City of El Paso – City Plan Commission Staff Report

Case No: SUSU14-00074 – Vista Del Prado Unit Three Replat A
Application Type: Resubdivision Combination
CPC Hearing Date: September 25, 2014
Staff Planner: Nelson Ortiz, (915) 212-1606, ortiznx@elpasotexas.gov
Location: South of Americas and West of Alameda
Acreage: 1.0205 acres
Rep District: 6
Existing Use: Single-family dwellings
Existing Zoning: R-4/sc / R-3/sc (Residential / special contract)
Proposed Zoning: R-4/sc / R-3/sc (Residential / special contract)
Nearest Park: Caribe Park (.28 mile)
Nearest School: Hueco Elementary School (1.6 miles)
Park Fees Required: N/A
Impact Fee Area: N/A
Property Owner: Juana Contreras, Anabel Salazar and Francisco and Luz Arrieta
Applicant: Juana Contreras, Anabel Salazar and Francisco and Luz Arrieta
Representative: CAD Consulting Company

ATTACHMENT 4

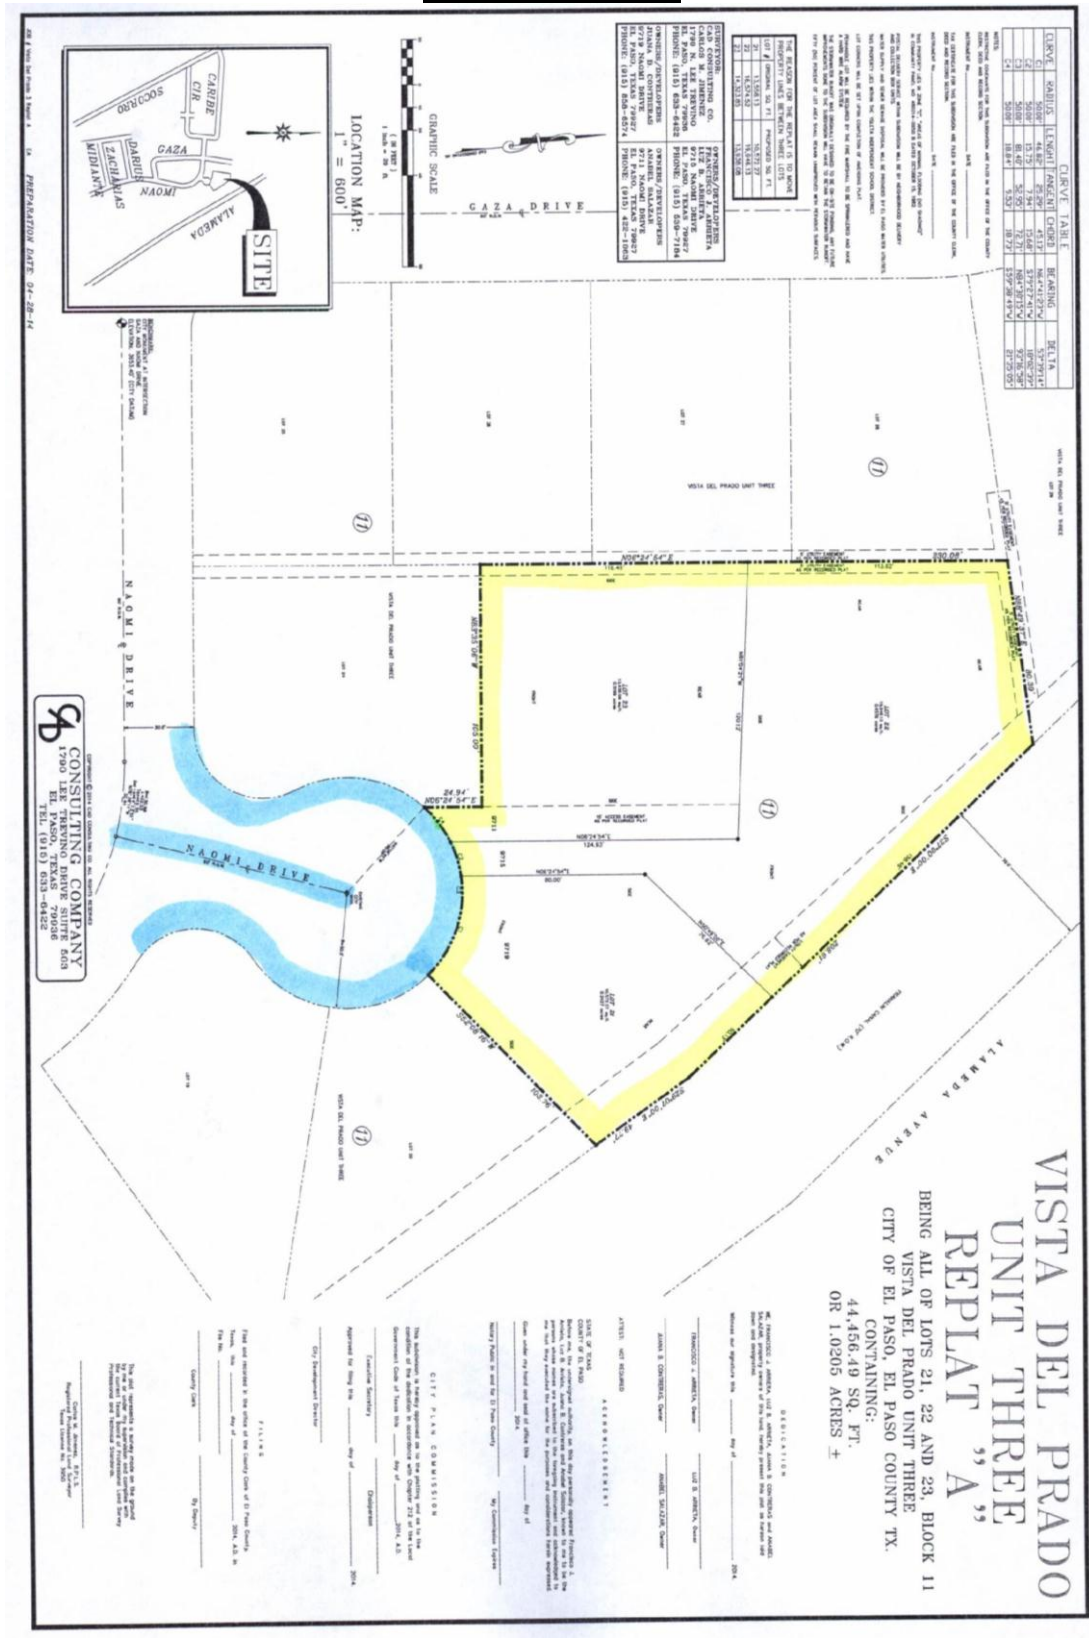
1. Include a note stating that the stormwater runoff was originally designed to be on-site ponding, any future improvements done to the subdivision will have to retain the stormwater runoff.
2. Correct cross Section A-A, area shows concrete header, and not curb and gutter; also include slope percentage.
3. Add note on final plat: Fifty (50) percent of lot area shall remain unimproved with pervious surfaces.
